# JONES & BEACH ENGINEERS INC.

**RE: Response Letter 2  
19 Old Gonic Road, Rochester, NH  
Tax Map 131, Lot 1  
JBE Project No. 21090**

We are in receipt of comments from Theresa Hervey, Town Assessing Department, Ryan O'Connor, Conservation Commission, and Dana Webber, Department of Public Works dated September 27, 2022. Review comments are listed below with our responses in bold.

# PROPOSED SITE PLAN "BAYBERRY COMMONS"

DRAWING No.  
**OVRS**  
SHEET 9 OF 48  
JBE PROJECT NO. 21090

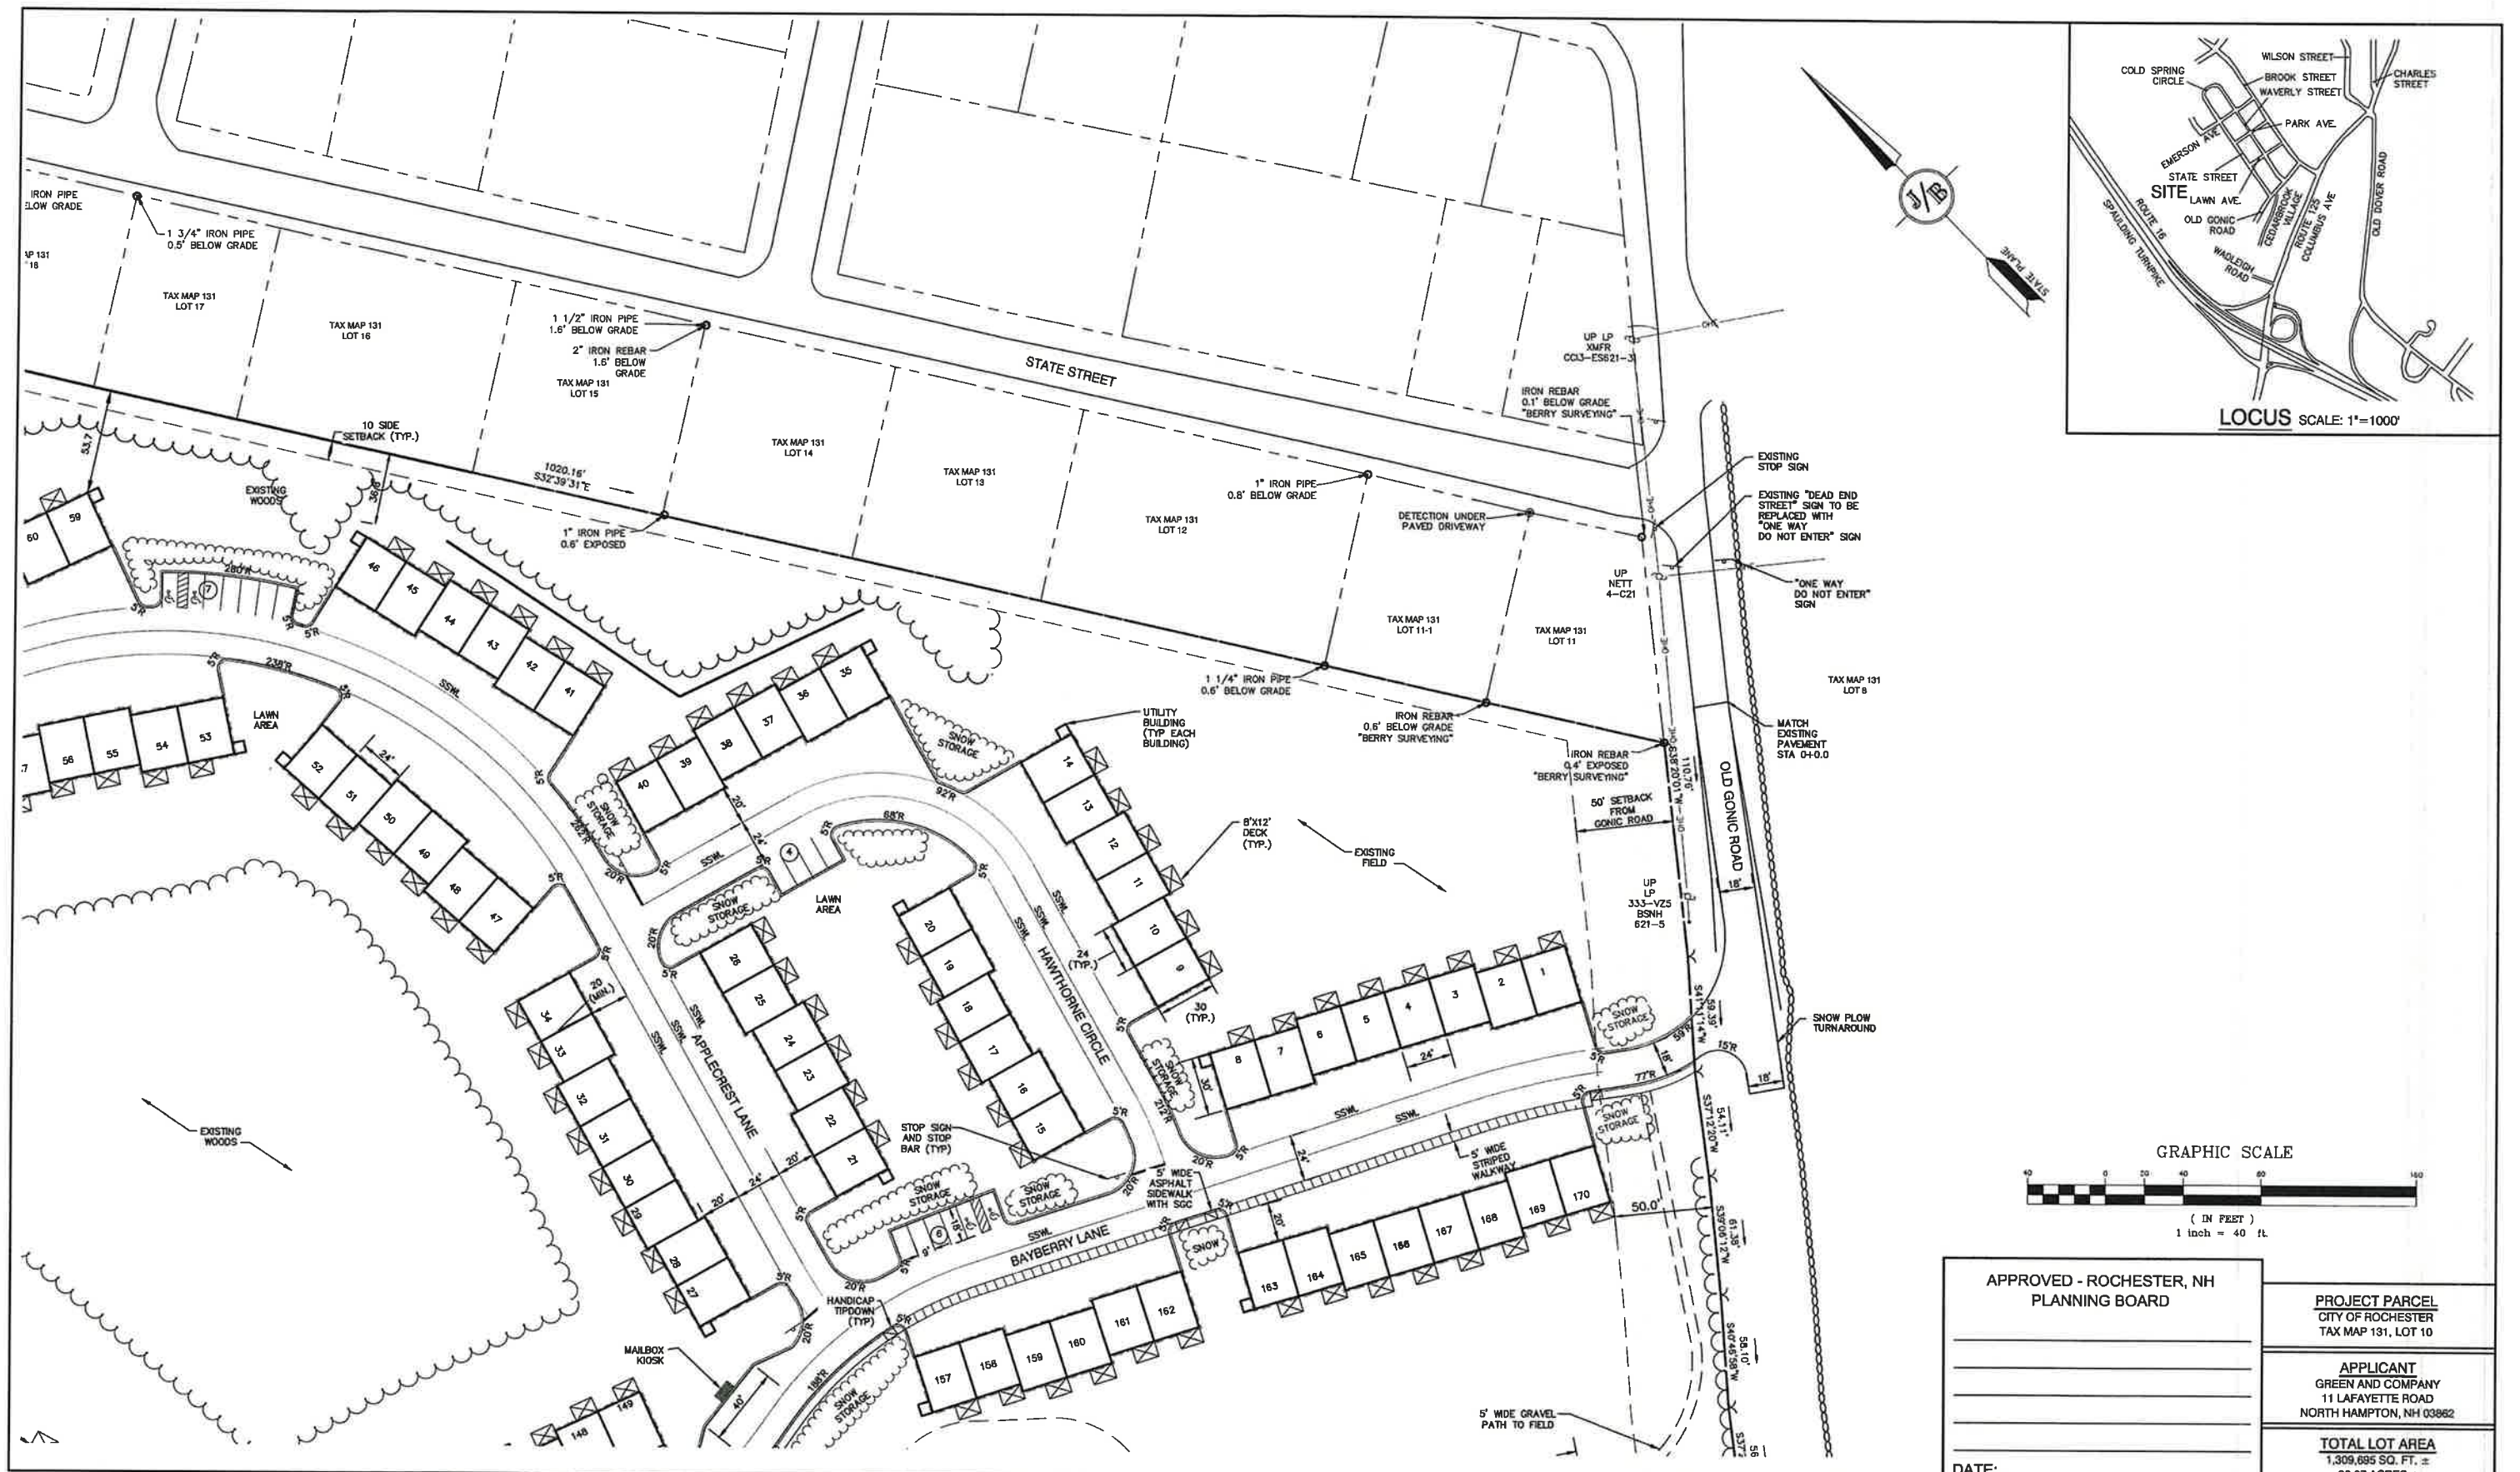
3. *Please add the following plan notes:*

*- A neighborhood meeting is required prior to any blasting on site.*

*- On-site roads, infrastructure, and amenities shall all be privately maintained.*

**The above note has been added as Note #22 on Sheet OVRs.**

**The above note has been added as Note #23 on Sheet OVRs.**

DRAWING No.  
**OFF1**  
SHEET 35 OF 48  
JBE PROJECT NO. 21090

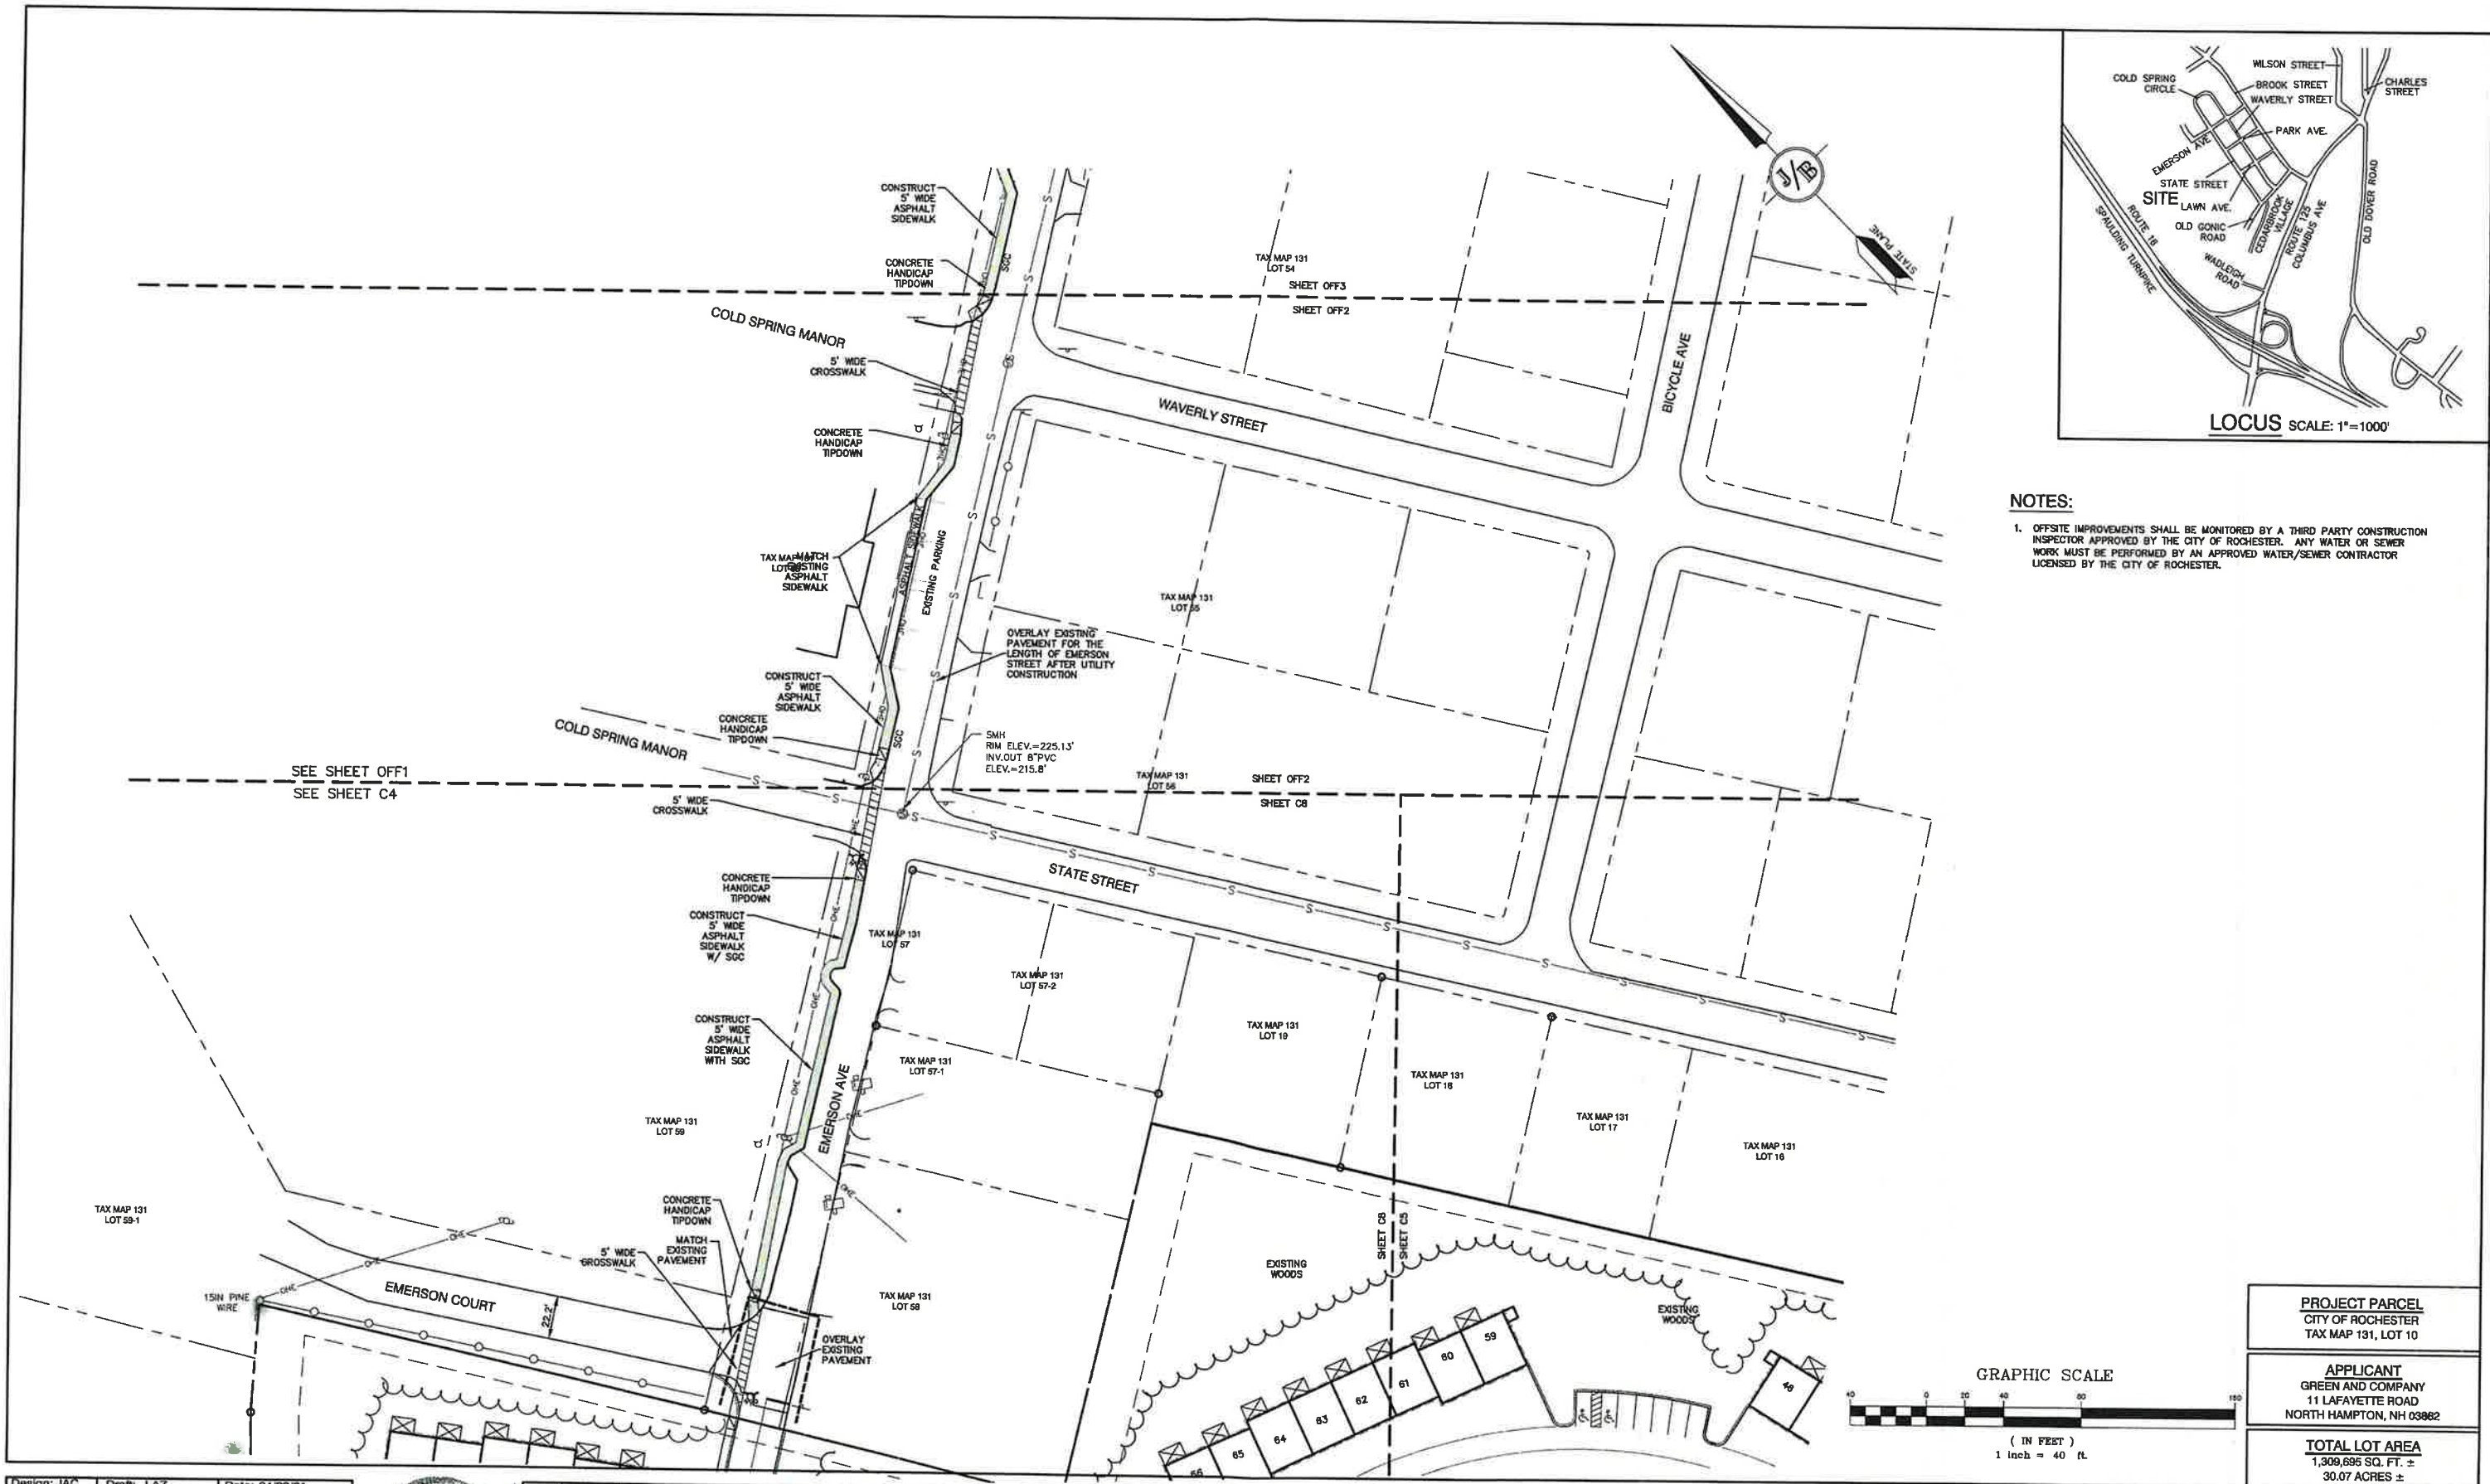
- j. Sheet OFF1 shows half of the existing conditions, provide a match line or note referencing Sheet C4 for continuation of existing conditions in offsite improvement area.

**RESPONSE: A note referencing Sheet C4 has been added to show the continuation of existing conditions in the offsite improvement area.**
- k. Sheet OFF4, the existing DMH near Emerson Court is shown covered by new sidewalk. Relocate the DMH or sidewalk. Please review all drainage, grading and conflicts in the City ROW for the offsite improvements.
